June 7, 2023

> Subject: DNR Review of Interim & Remedial Action Status at

> > Community Within the Corridor - East Block 2748 N. 32nd Street, Milwaukee, WI 53210 BRRTS #02-41-263675, FID #241025400

# FIGURE 4

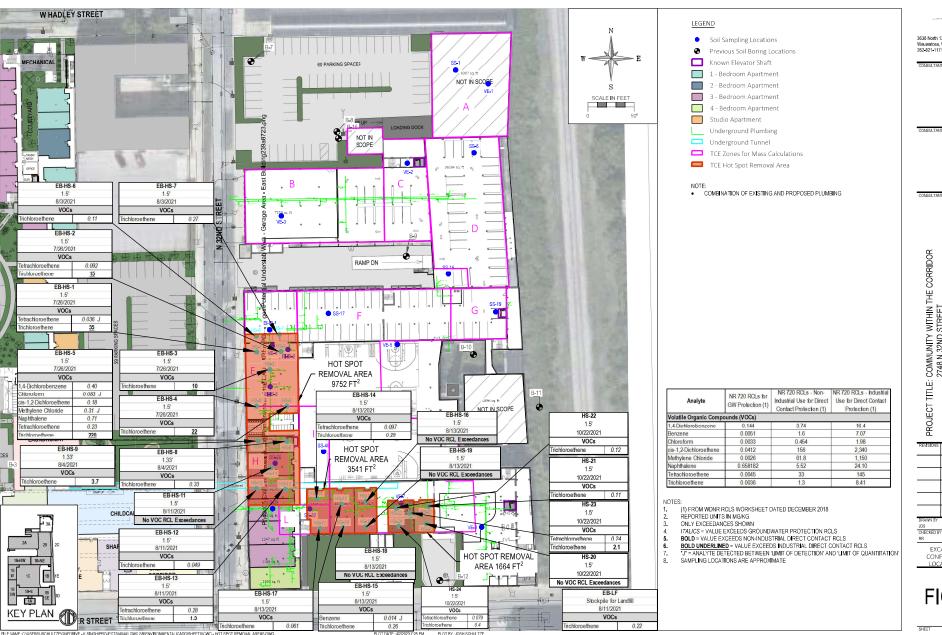
- On April 7, 2023, CWC submitted *Interim Remedial Action Documentation Report* (April 2023 Report) to the DNR. The April 2023 Report indicated that in August 2021, approximately 1,765 tons of contaminated soil was removed from beneath Building 1B, as shown on Figure 4 of the April 2023 Report (attached).
- CWC's Status Reports have provided information on the corrective actions that have been or are being
  implemented at the building complex. At this time, the actions are focused on modifying the VMS and
  sealing preferential pathways where contaminated vapors may be entering the building complex. CWC is
  taking these steps because the VMS is not currently functioning as intended. Because SVE is a
  component of the site's VMS, it appears based on the information provided by CWC that the SVE is also
  not occurring as intended.

The highest concentration of TCE identified in soil during CWC's site investigation (pre-soil excavation) was at sample location EB-B-29, with TCE at 87 mg/kg from 2-4 feet below the building's slab. This sample location is within Building 1B, which is where some of the highest concentrations of TCE soil contamination were identified during the site investigation. As presented in the April 2023 Report, the remedial soil excavation performed within Building 1B extended to 1.5 feet below the building's slab. Following soil excavation, CWC collected confirmation soil samples from the base of the excavation cavity (at 1.5 feet below the building's slab). The highest concentration of TCE identified in the confirmation samples collected within the remedial excavation limits was 220 mg/kg at sample location EB-HS-5. Several confirmation samples collected from within the remedial excavation limits and several soil samples that were not excavated (i.e., deeper than the excavation limits), such as EB-HS-5 and EB-B-29, indicate that a significant amount of soil contamination remains beneath Building 1B, which will likely act as a continuing source for potential vapor intrusion.
